Randwick Local Planning Panel (Public) Meeting

Development Application Report No. D56/25

Subject: 130-134 Coogee Bay Road, Coogee (DA/535/2025)

Proposal:	Demolition of existing buildings/structures, tree removal and construction of a shop top housing development over 8 levels 6 habitable levels with 21 residential units, 3 commercial tenancies and 2 levels of basement containing 42 car spaces (accessed from Powell Lane).
Ward:	East Ward
Applicant:	The Trustee For The CBR9 Trust
Owner:	Cbr9 Pty Ltd & Ms C J Sharpe
Cost of works:	\$13,076,949.63
Reason for referral:	Development contravenes the development standard for floor space ratio and building height by more than 10% and 29 unique submissions by way of objection were received.

Figure 6: Height of building components.

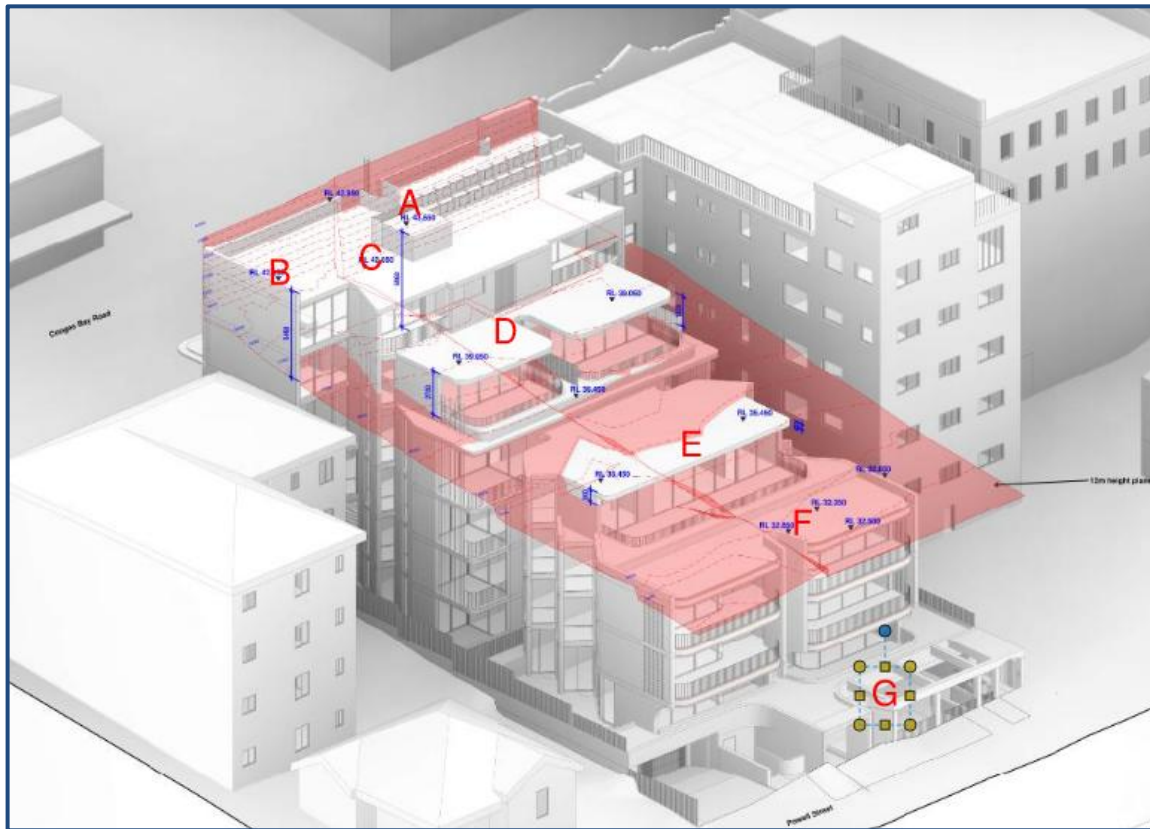
Height of building shown in figure 6 further below–

- 18.15m** maximum building height from lift overrun (RL 43.65) to ground level (RL25.50).
- 16.71m** (CBR and side roof parapet at eastern at RL42.95 to ground at RL25.34).
- 16.81m** (Second floor roof behind at RL42.05 to ground at RL25.24).
- 14.4m to 14.87m** (First floor roof in middle at RL39.05 to ground at RL24.65/RL24.18).
- 12.4m to 12.8m** (CBR ground level rear roof at RL35.45 to ground in middle at RL23.05 to east at RL22.65).
- 10.20m to 10.53m** (From lower ground level 1 roof parapet at RL32.85 to ground eastern corner at RL22.65 and to ground western corner at RL22.32) and **10.04m to 10.51m** (From lower ground level 1 rear middle at RL32.50 to ground rear west middle at RL22.46 and to ground rear east middle at RL21.99). 3 storeys above existing ground level and 4 storeys above Powell Lane level.

G. 3.16m (Powell Lane ground floor roof at RL24.05 to ground at middle RL20.89).

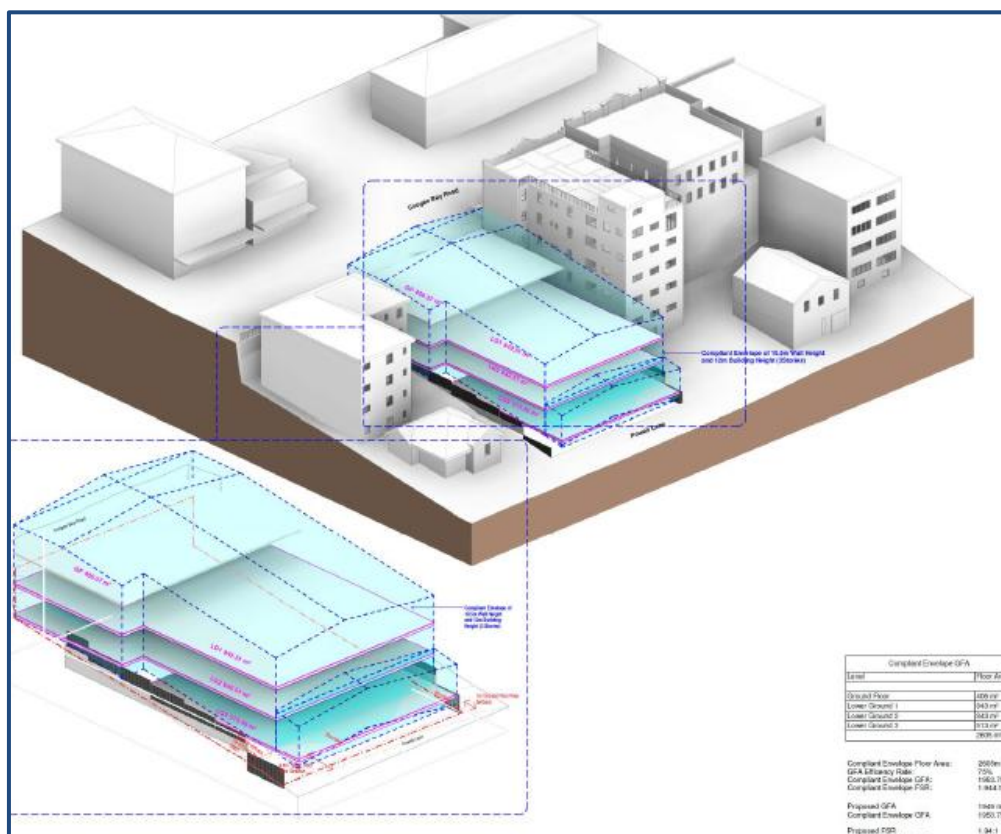
Assessing officer's comment: In conclusion, the applicant's written request has not adequately demonstrated that compliance with the floor space ratio development standard is unreasonable or unnecessary in the circumstances of the case. The non-compliant FSR is directly responsible for not satisfying the objectives of clause 4.4 of RLEP 2012 having regard to the following:

- (i) Objective (a) as it will result in a building form that is not consistent with the desired future character of the locality.
- (ii) Objective (d) as it will adversely impacts on the amenity of adjoining and neighbouring land in terms of visual privacy, acoustic privacy, solar access, and view sharing.

The proposal namely the distribution of built form in particular the rear elements of the development are not considered to satisfy the objectives of the FSR standard for the following reasons:

- Excessive rear elements: The scale and bulk at the rear are inconsistent with the existing and desired future character, failing to provide a proper transition to the medium-density zone (9.5m height, 0.75:1 FSR). The design does not respect the established streetscape or built form along Powell Lane.

Figure 12: Mark-up of Drawing No. DA.02 of the architectural plans prepared by Studio GA illustrating the existing private open space area.

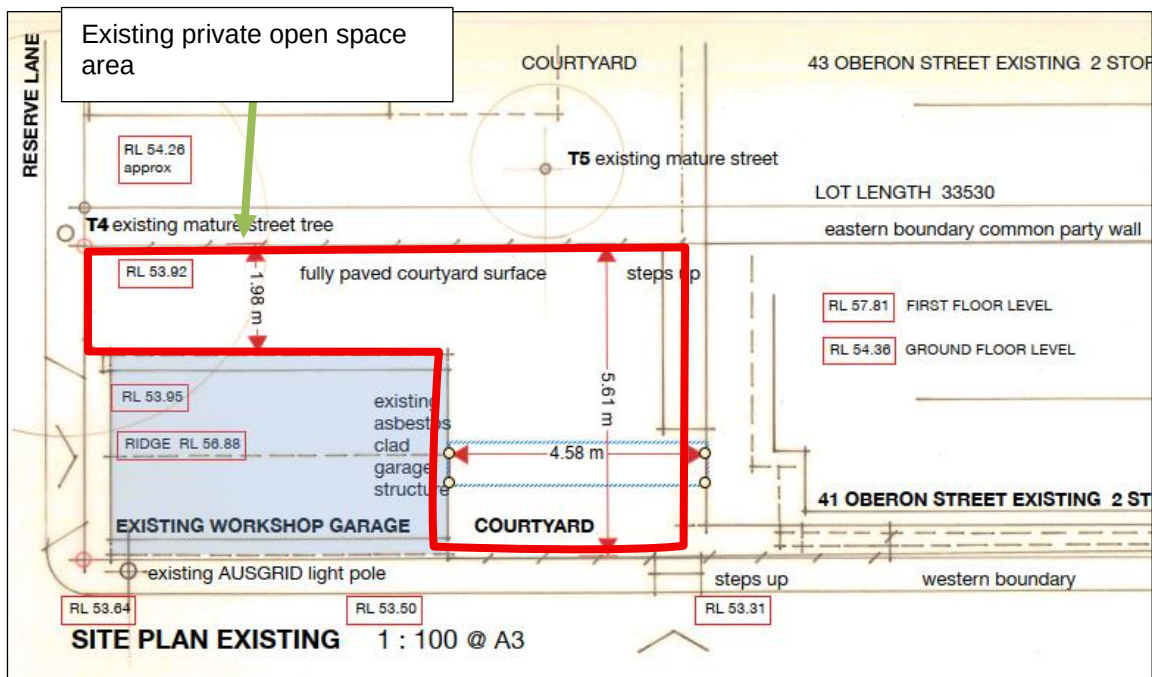
The subject site is currently constrained in terms of private open space in the rear yard due to the current orientation of the garage, which is located along Oberon Lane. This results in the rear yard containing a L-shaped private open space area, which features a passageway along the eastern side of the current garage. However, this passageway offers little usability and amenity to the residents of the subject site. The proposed alternative to the current arrangement includes a garage orientated along Reserve Lane. This alternative results in a squared-off private open space area that is increased in terms of usability and amenity. It also enables the proposed private open space area to meet the required dimensions for private open space areas as specified in Section 2.7 of Part C1 of the RDCP 2023. See Figures 12 and 13 below:

Figure 14: Extract of Drawing No. DA02 of the architectural plans prepared by Studio GA, as submitted with DA/312/2024, illustrating the eastern elevation of the originally proposed garage.

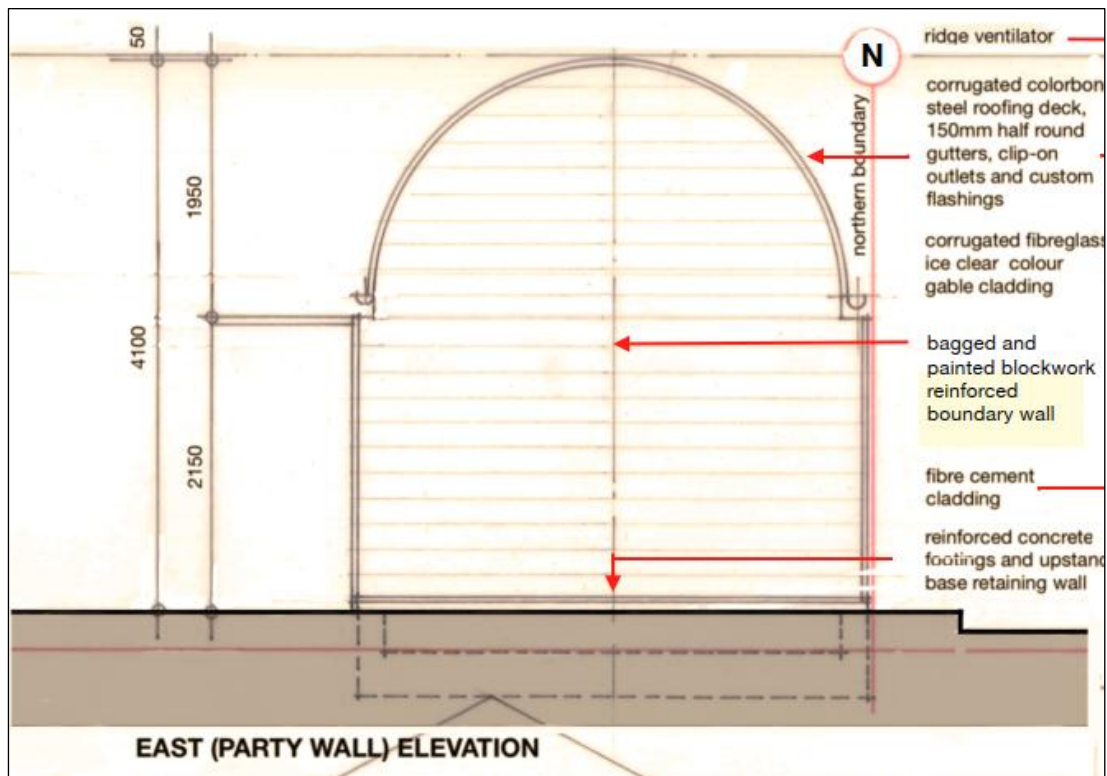
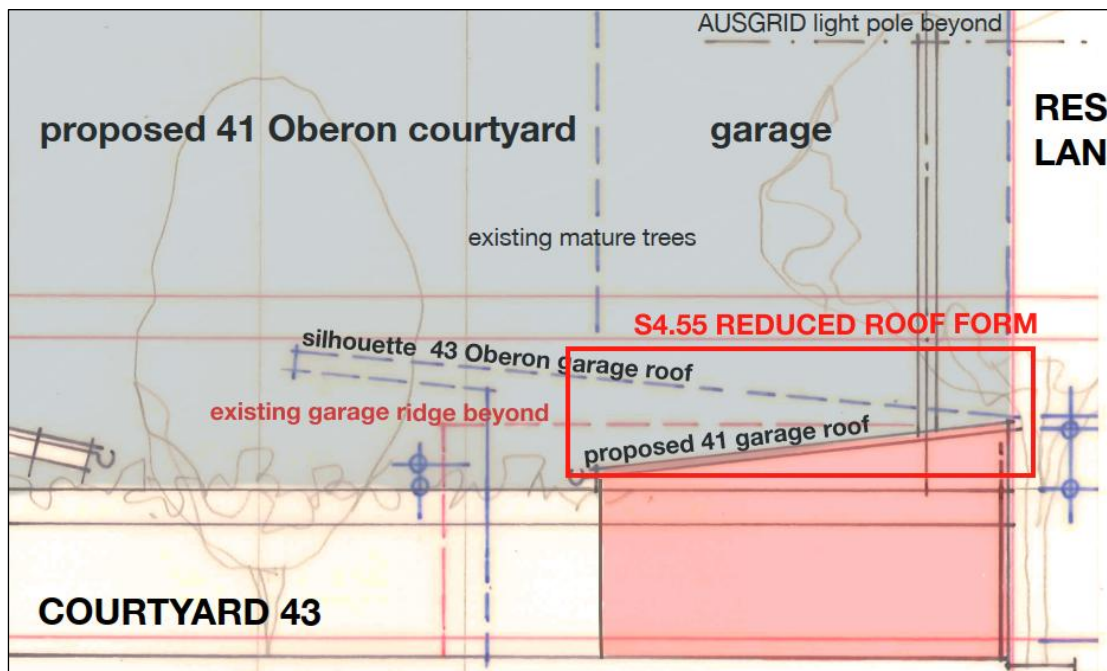
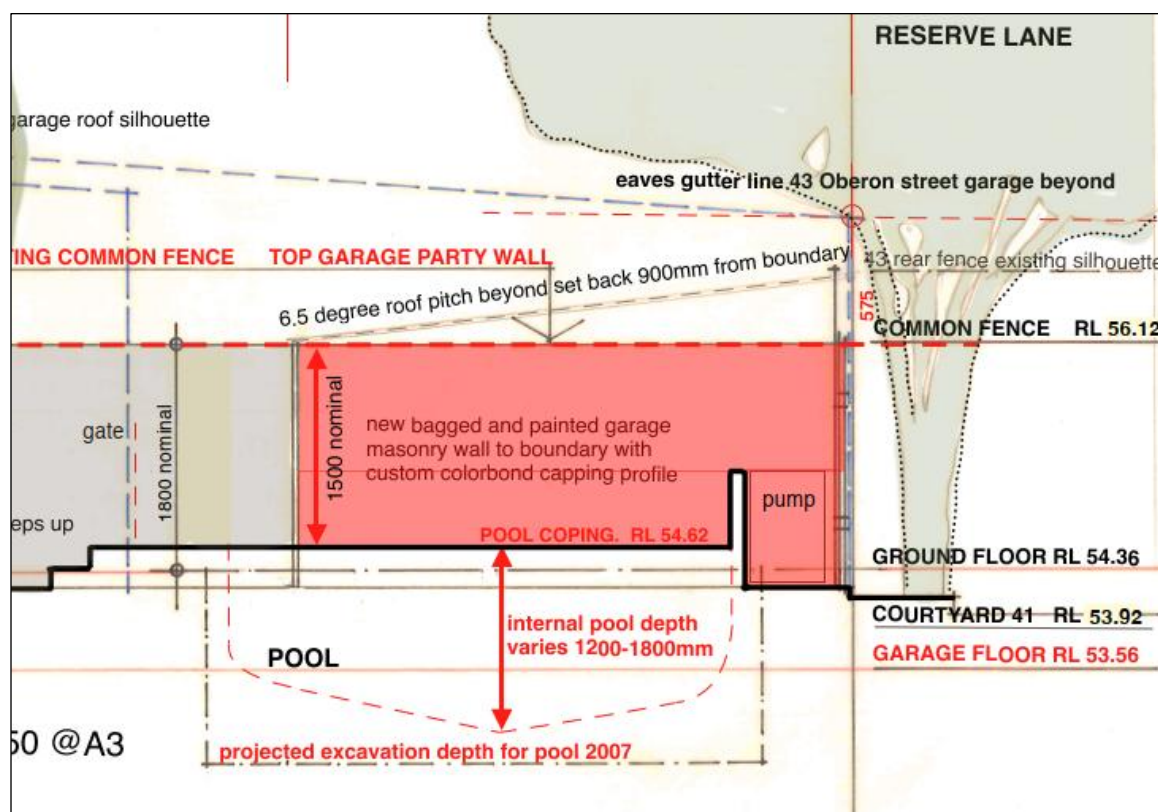
The proposed garage has also been amended since DA/312/2024 and DA/312/2024/A, and its scale has been reduced. The reduced scale has been achieved through the deletion of the semi-circular roof and the provision of a skillion roof form, which is consistent with the character of the laneway. The skillion roof design that was submitted as part of DA/312/2024/A, and this application has been further amended by the Applicant to address the concerns raised by a Submitter at No. 43 Oberon Street (the immediate neighbour to the east). The overall height of the garage has been reduced by 200mm, and the Applicant has amended the roof form to provide an elongated box gutter that immediately adjoins the boundary of No. 43 Oberon Street for a depth of 900mm. This section will not exceed the existing height of the common fence line.

The transition of the roof form from DA/312/2024 to this subject application can be visualised below (see Figures 14 to 16).

The Applicant has amended the design of the garage to ensure that no point exceeds the height of the existing common fence line. As such, there will be no discernible perception of bulk immediately on the boundary. The skillion roof form is setback 900mm from the boundary, which would be a standard setback requirement for non-laneway/garage development under the RDCP 2023.
